CITY OF NEW YORK
DEPARTMENT OF ENVIRONMENTAL PROTECTION
BUREAU OF ENGINEERING DESIGN & CONSTRUCTION
WM-30 WATERSHED IMPROVEMENTS
RECONSTRUCTION OF
CATSKILL WATERSHED DAMS AND ASSOCIATED FACILITIES

GILBOA DAM AND ASSOCIATED FACILITIES RECONSTRUCTION
CONTRACT CAT-212B
ARCHITECTURAL
DAM RECONSTRUCTION
DETAILS - SHEET 5 OF 5

90% SUBMITTAL

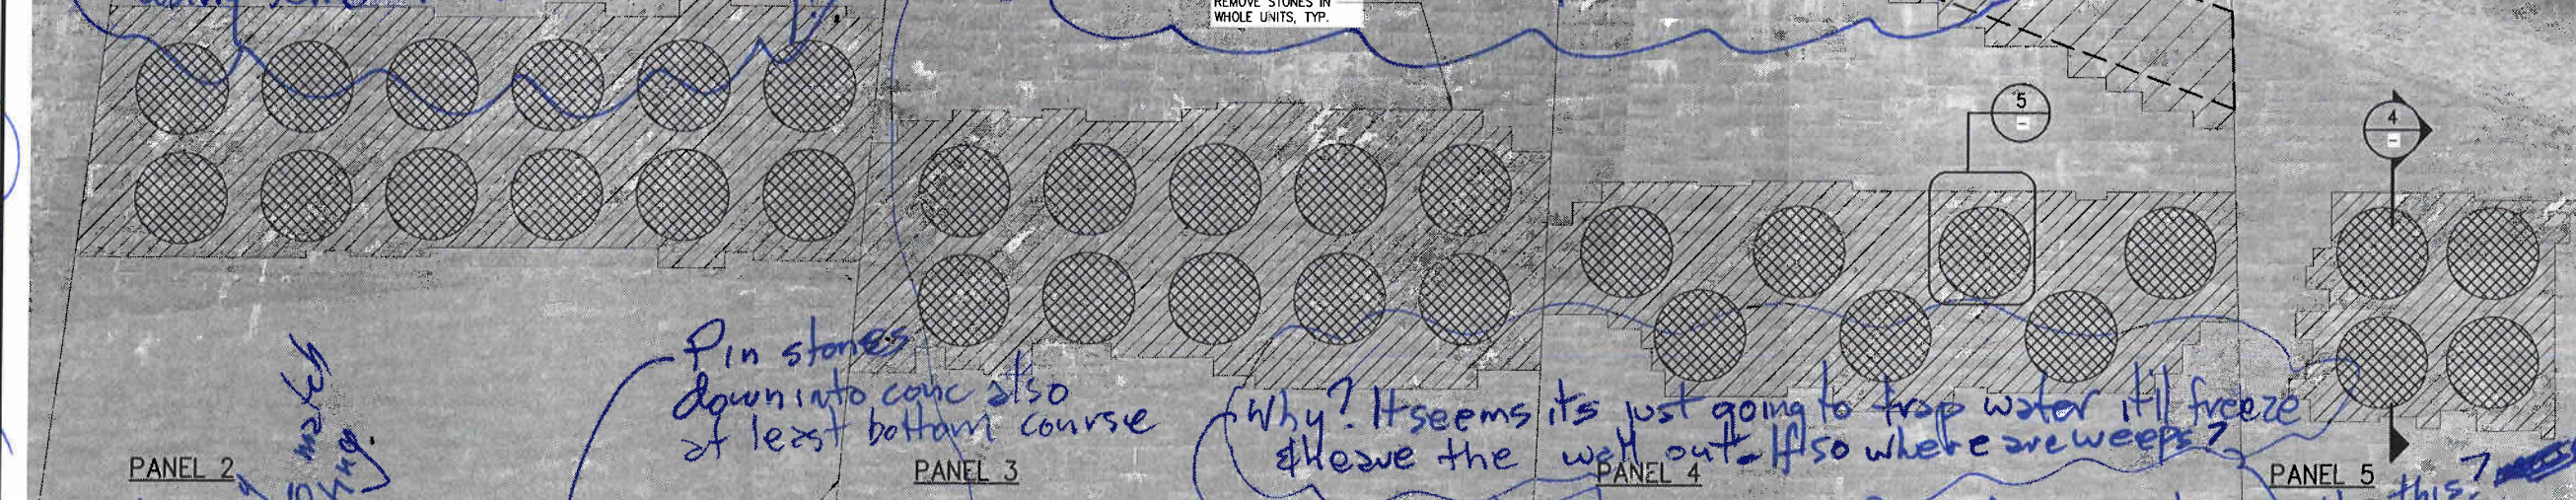
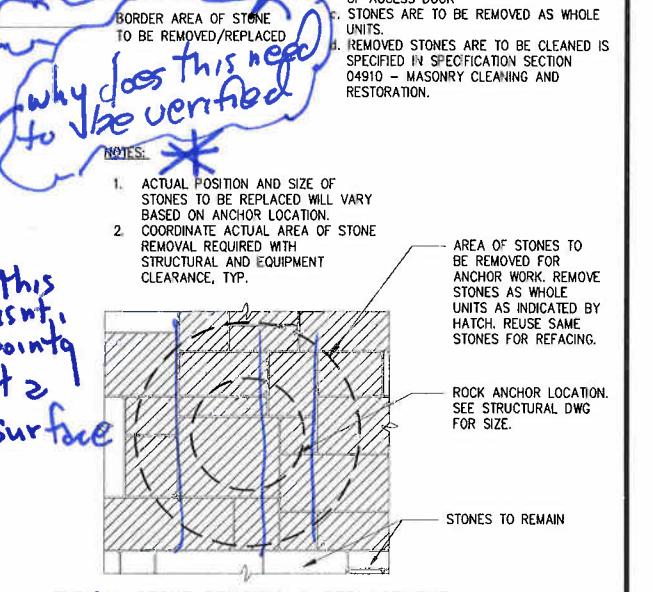
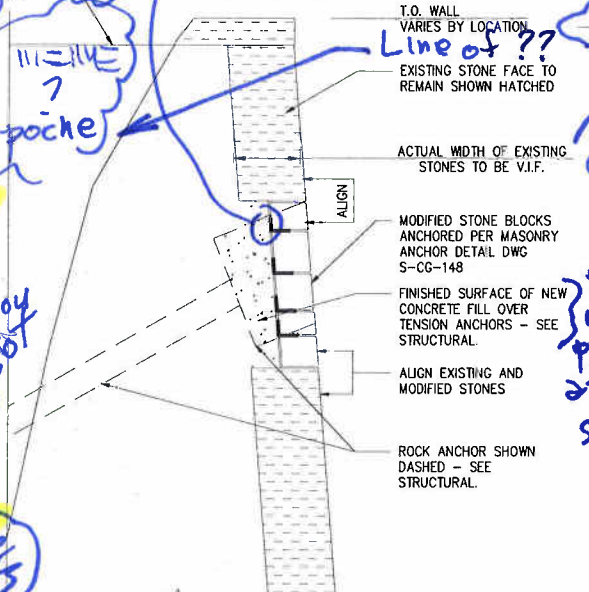
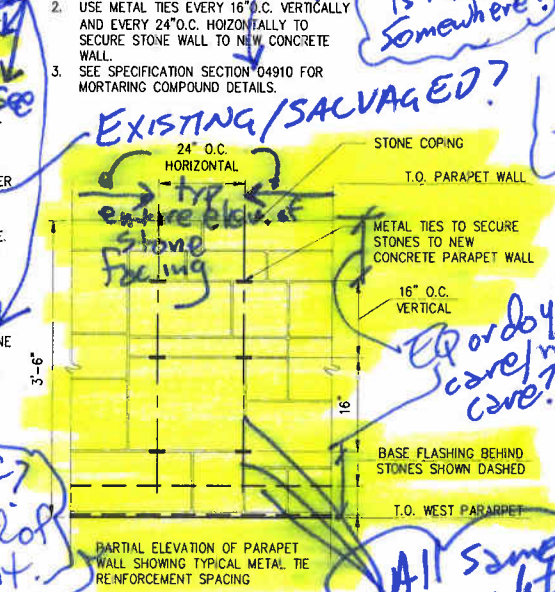
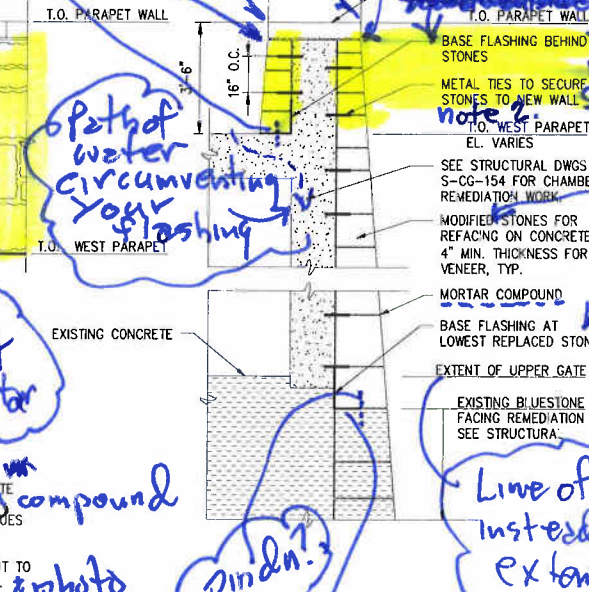
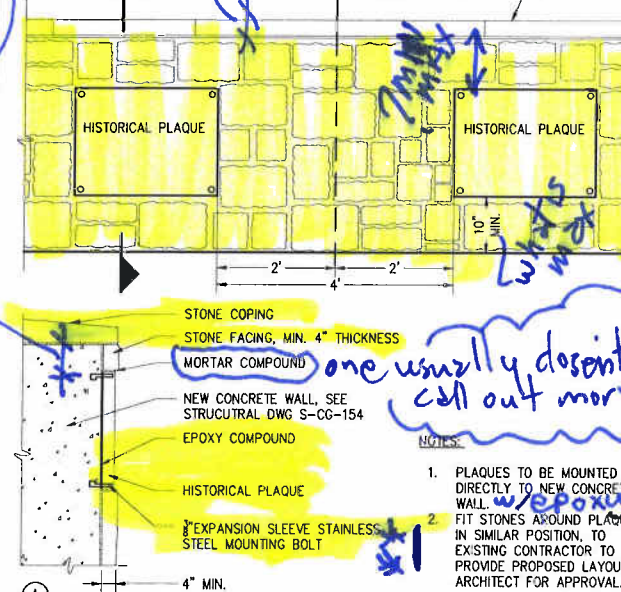
Min dim to ensure An enough from edge to prevent cracking when anchor tightened

*I have 4 sets of notes using same numbers - confusing!

Flush joint or overhang w/ or w/o drip
